From: Murray Evans <murray@mevansholding.com>
Sent: Thursday, February 3, 2022 4:32 PM
To: Millar, Chris <Chris.Millar@niagararegion.ca>
Cc: Bowie, Greg <Greg.Bowie@niagararegion.ca>; Federici, John <John.Federici@niagararegion.ca>; Sergi, Michelle <Michelle.Sergi@niagararegion.ca>
Subject: 171 Gorham Road, Town of Fort Erie

**Re: Natural Heritage System Review and Analysis
171 Gorham Road, Town of Fort Erie, Ontario
Lot 25, Concession 1**

SETTLEMENT AREA BOUNDARY REVIEW ASSESSMENT SHEET COMMENTS

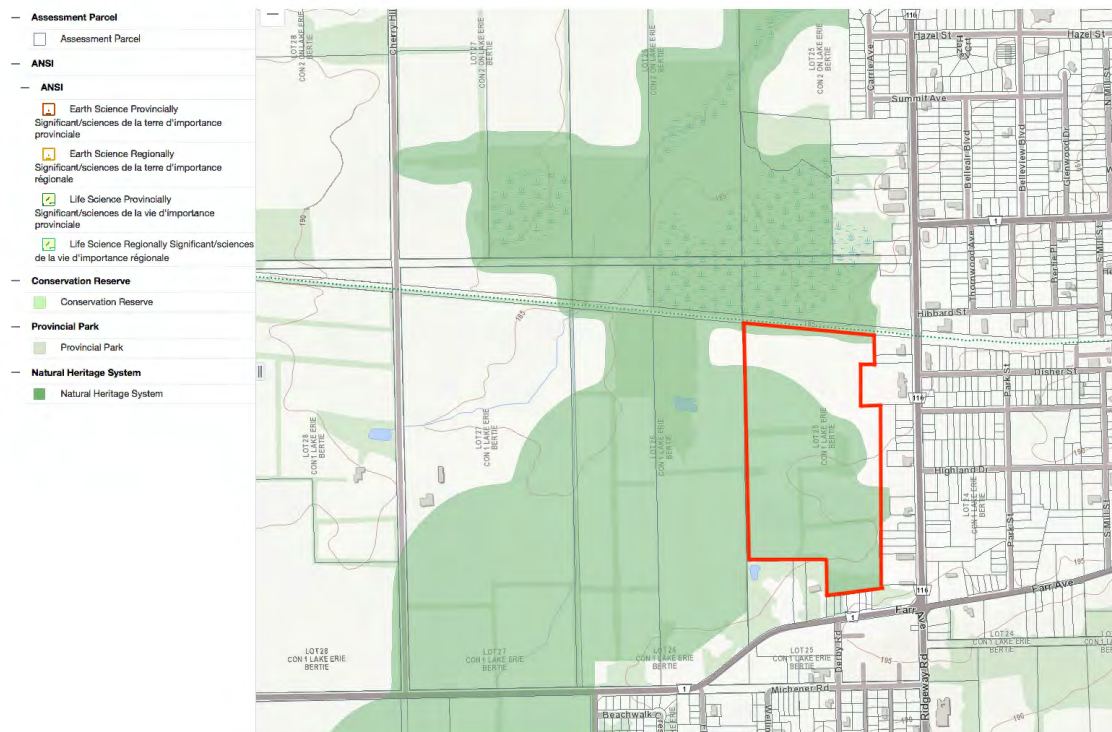
Criteria Response: Approx. half shown as NHS

Comment: Woodlands, Wetland Buffer, Fish Hab and Corridor functions – western half heavily impacted by PNHS

We agree that the current official mapping roughly shows the western half of the parcel in the NHS layer. Notwithstanding, it is uncertain what specific criteria were used to draw the NHS boundary on the parcel. The guiding principle of designing an NHS is to base it on core natural heritage features of value (such as woodland or wetland), followed by landscape linkage considerations. However, no such features are located on the parcel, except for a fringe of woods along the southern boundary and a PSW north of the parcel on the north side of the Friendship Trail (see separate discussion below). The NHS's eastern boundary is partly defined by the backs of existing housing lots at Gorham Road. The boundary then bends and cuts northwestward across the agricultural field. It is unclear why the boundary would apparently *arbitrarily* divide an otherwise homogeneous crop field into its "NHS" portion on the west, and "non-NHS" portion on the east. There is no ecological rationale for the division and thus we disagree with this artificial split. (The "sinus" in the shape of the NHS at that location [white lobe in the northwest corner] appears to be, as we observe, a mapping artefact of copying directly from the Niagara OP mapping on Schedule C1 – Natural Environmental System Overlay and Provincial Natural Heritage Systems.)

Secondly, we question the inclusion of the rest, i.e., the western half of the parcel, in the NHS. Apart from the few remaining tree and shrub hedgerows in the centre of the parcel, all narrow, discontinuous and some composed of invasive tree species, there are no natural heritage features there that would justify the NHS designation.

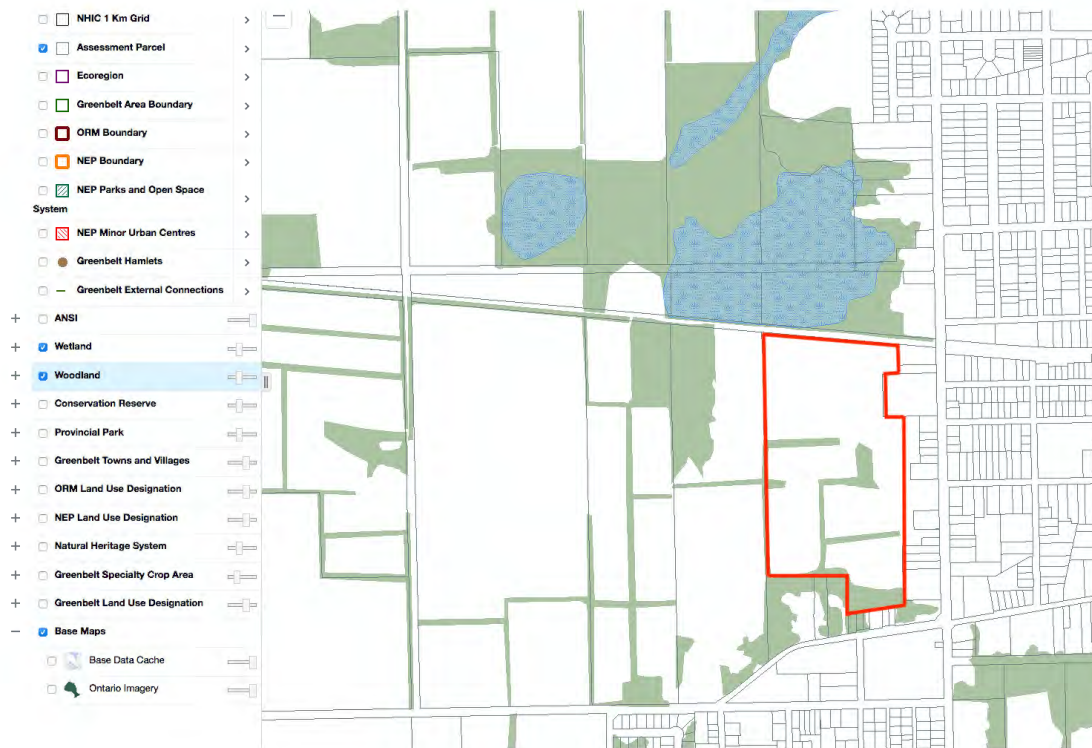
Thirdly, the NHS map, inaccurately, includes only the southern half of a distinct habitat feature (moist to wet shrub area with sparse tree cover) in the northwest corner of the parcel, as shown on the NHS map below, with added satellite imagery as base map layer.

We see no reason why the NHS would not include the northern half of this feature, compositionally and structurally identical to the southern half. The feature is recognized in the Fort Erie OP as “*Environmental Conservation*”. Furthermore, the OP also maps this area as “Woodlands >2ha” in size and as “Significant Natural Areas”. In our opinion, this feature likely meets the criteria for inclusion within NHS. The development concept for the property recognizes its existence and proposes its exclusion from the development footprint.

SKETCH TO ILLUSTRATE SITE ELEVATIONS AND PERCENTAGE SLOPE

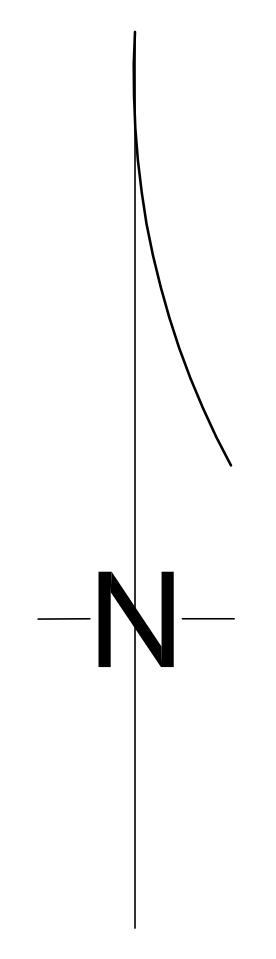
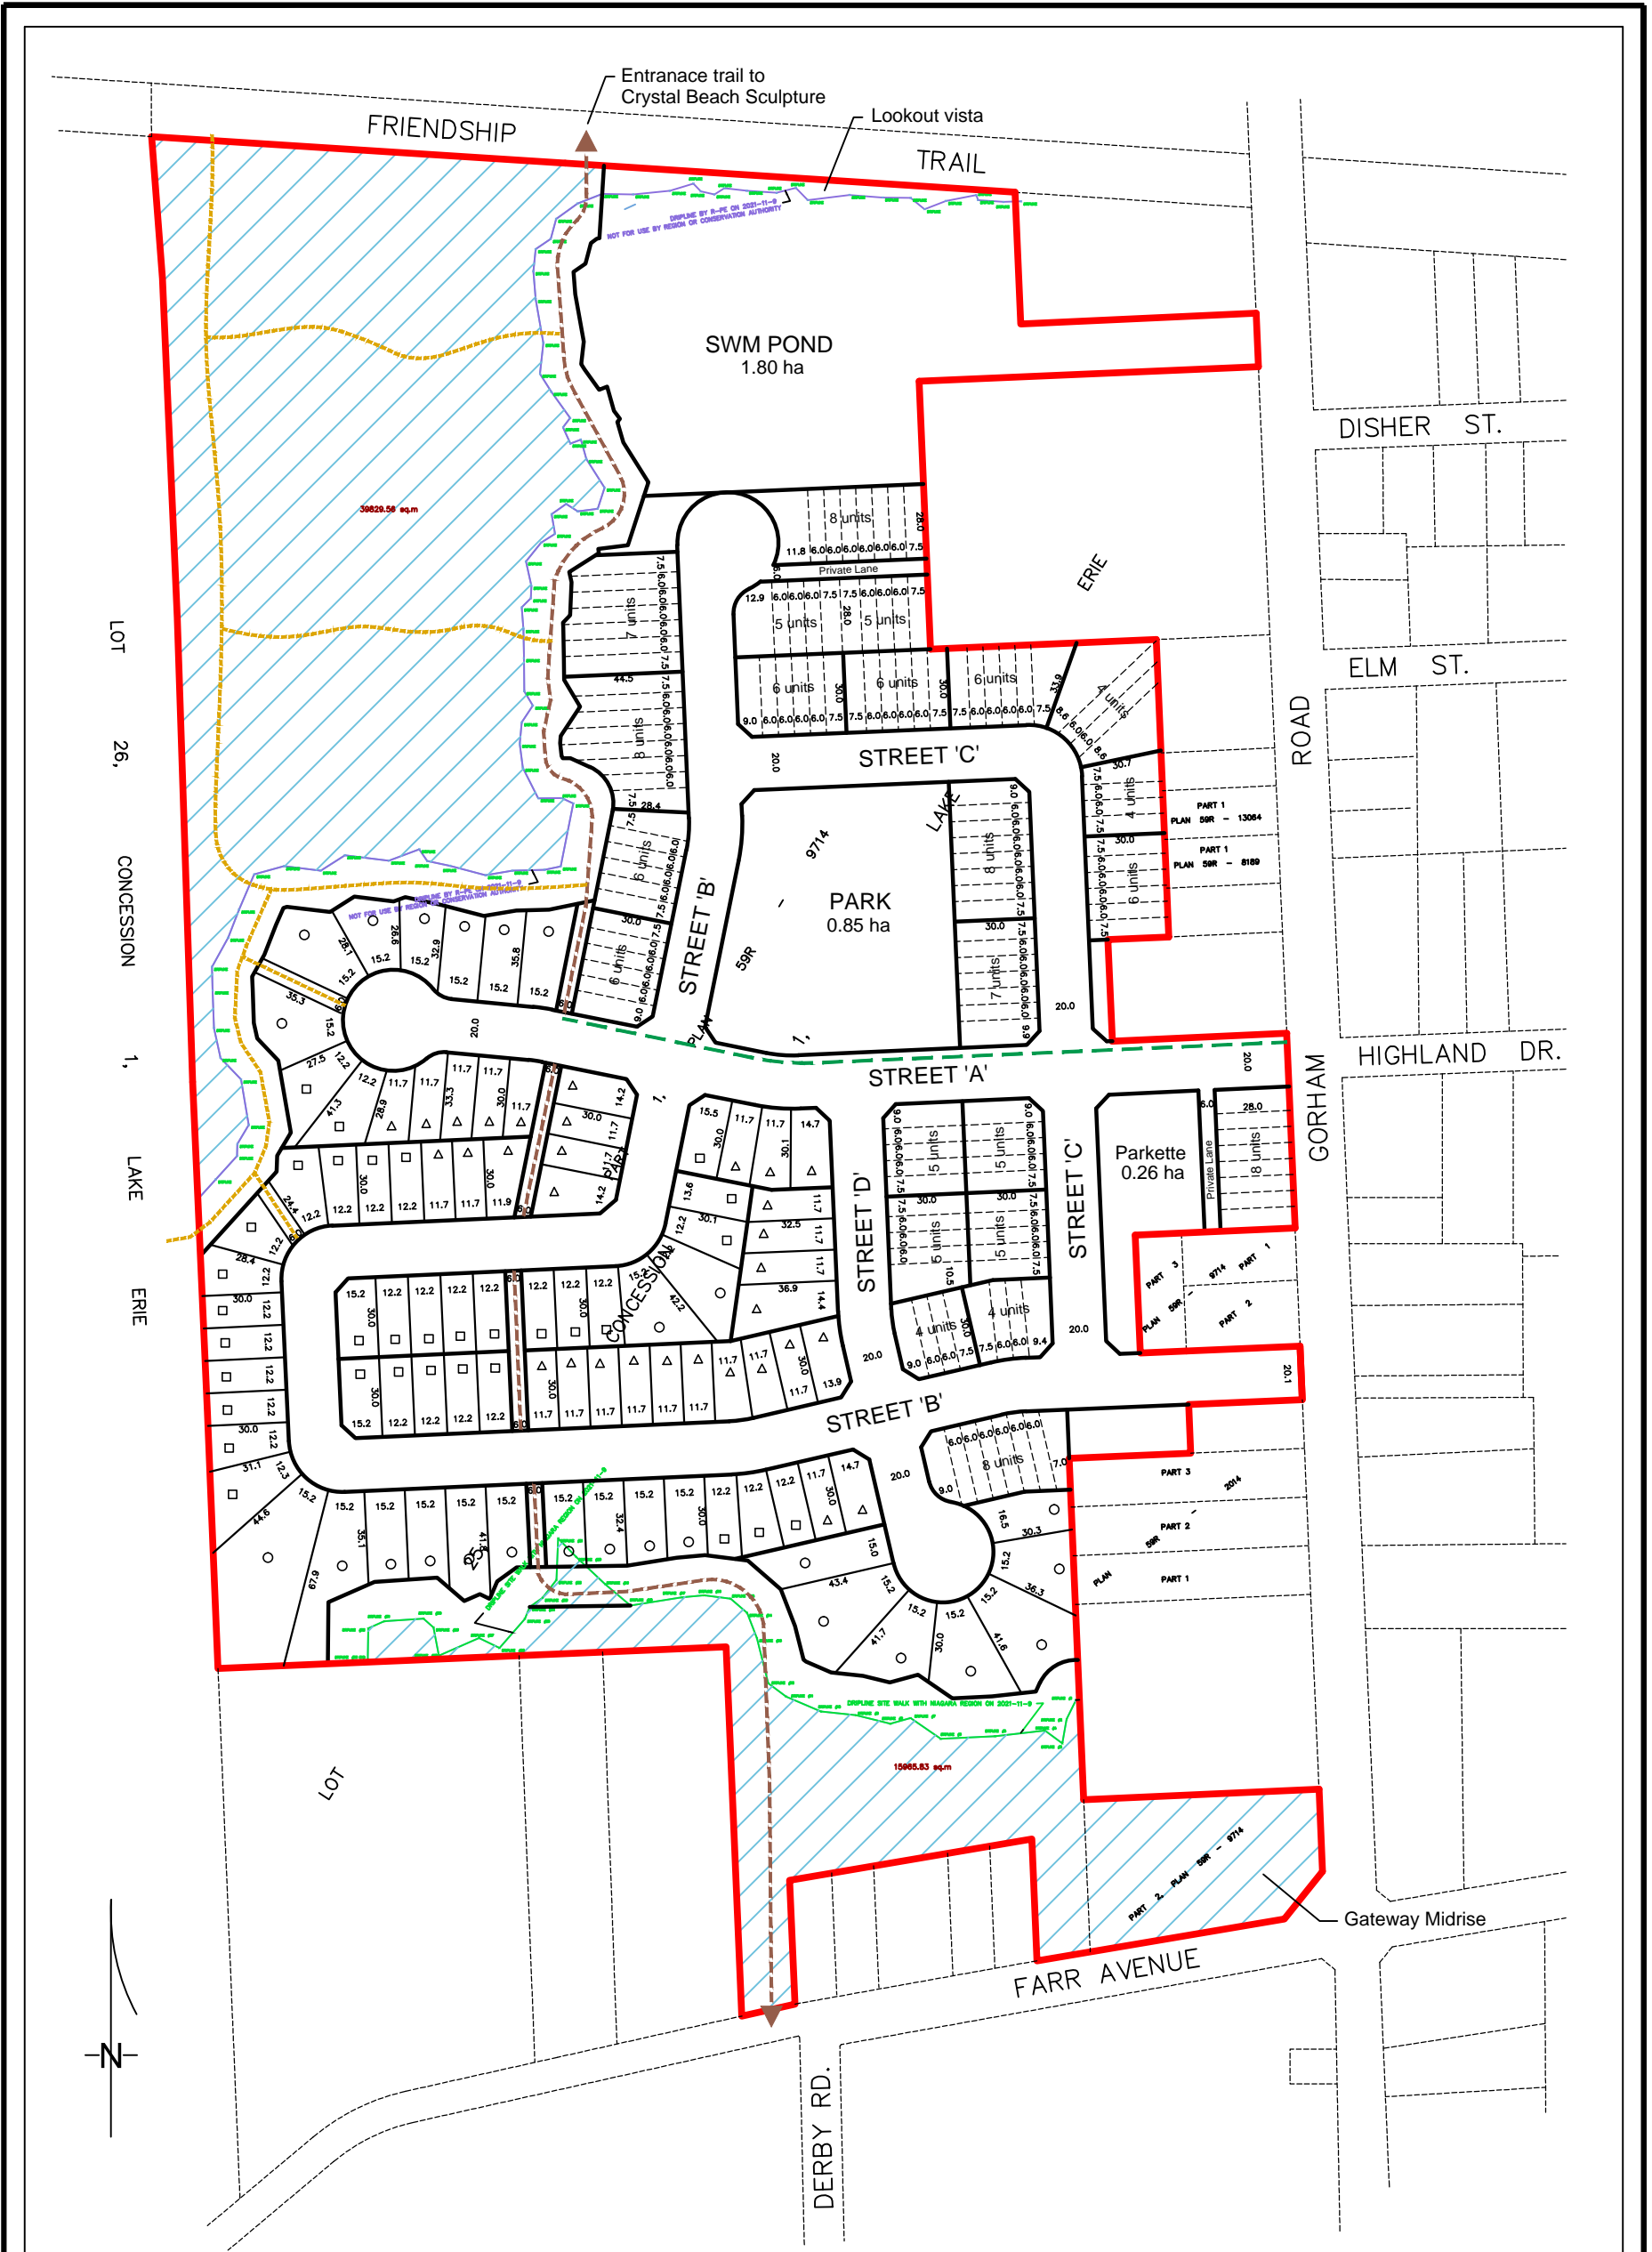
Comment: 8m grade change moving east to west	Comment:

<ul style="list-style-type: none"> • 5.8 grade change moving east to west, based on Ontario Land Surveyor • Site slopes between 1%-2%
<u>AGRICULTURE AGRI-FOOD NETWORK</u>
